Summary of Changes from BSIM-BULK107.2.0 Beta0_1 to BSIM-BULK107.2.0 Beta0_2:

BSIM Group, IIT Kanpur, UC Berkeley

Fig. 1: A bias dependent NOIA is introduced when NOIA3 > 0 to model noise behavior in weak inversion region.

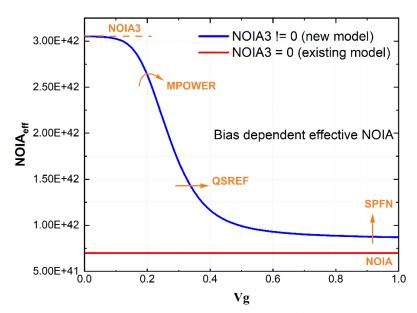
1. 2023enh2 (GF): Flicker noise model enhancement.

• In BSIM-BULK107.2.0 Beta0_1, the flicker noise model is not able to capture the drain current noise spectral density (S_{id}) data in the weak inversion.

• In BSIM-BULK107.2.0 Beta0_2, a bias dependent effective NOIA is introduced to model the noise behavior in weak inversion:

$$NOIA_{eff} = Max \left(1, \left(\frac{\frac{NOIA3}{NOIA}}{1 + \left(\frac{q_{ia}}{QSREF} \right)^{MPOWER}} \right) \right) * NOIA$$

- The default value of NOIA3 is 0 making the enhancement backward compatible.
- New parameters introduced in BSIM-BULK107.2.0 Beta0_2 for this enhancement: NOIA3, MPOWER, QSREF, SPFN.

Fig. 3: Capacitance plots obtained using BSIM-BULK 107.2.0beta0_1 code.

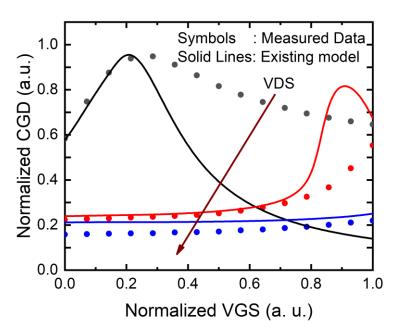
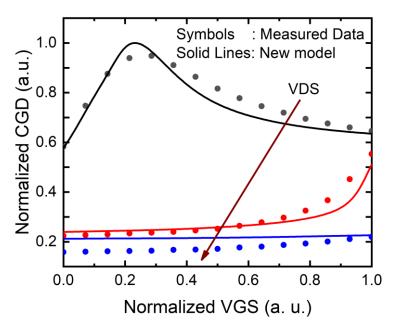
2. 2023enh3 (GF): Decoupling drain-side drift resistance for capacitance calculations.

- We have decoupled drain-side drift resistance used in I-V and C-V calculations with new parameter RDLCWCV used in capacitance calculations.
- The default value of RDLCWCV is RDLCW and therefore, for the default value, the drain-side drift resistance used in current and capacitance calculations will be the same.
- Decoupling is done in such a way that the internal drain potential, V(di), used in capacitance calculations is modified as shown below.
 - V(di)_{CV} = V(di)_{IV} + devsign * (1.0 RDLCWCV / RDLCW) * V(di1, di)
- This new enhancement provides more flexibility in capacitance fitting without affecting the current characteristic fitting.
- An example case is shown below. Fig. 3 shows the capacitance plots using BSIM-BULK 107.2.0 beta0_1 and Fig.4 shows the same using the new BSIM-BULK 107.2.0 beta0_2 code.

3. 2023bug3 (ADI): Issue in C_{GD} reciprocity while exercising QM parameters.

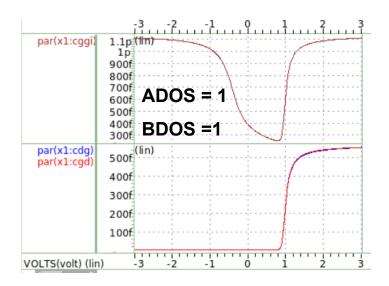
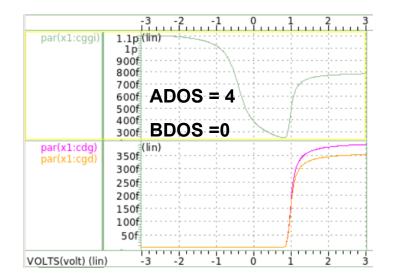
C_{GD} non-reciprocity was observed at 0V V_d bias while using QM parameters.

• We investigated the issue and concluded that non-reciprocity issue arises when the parameterized equation deviates too much from semi-physical expression (i.e., when BDOS=0, or based on parameter selection, a negligible contribution of the second term in the denominator).

- Also, physically [1,2] the QM contribution to capacitance typically runs between 10-15%, and we recommend not using the extreme values of QM parameters to achieve it. Furthermore, we have not restricted the parameter values for good fitting flexibility.
- We, however, have added a suggestion note in the Technical Manual for the same:
 - "QM contribution to capacitance is usually between 10-15%, and we recommend not using extreme values of QM parameters to achieve it".
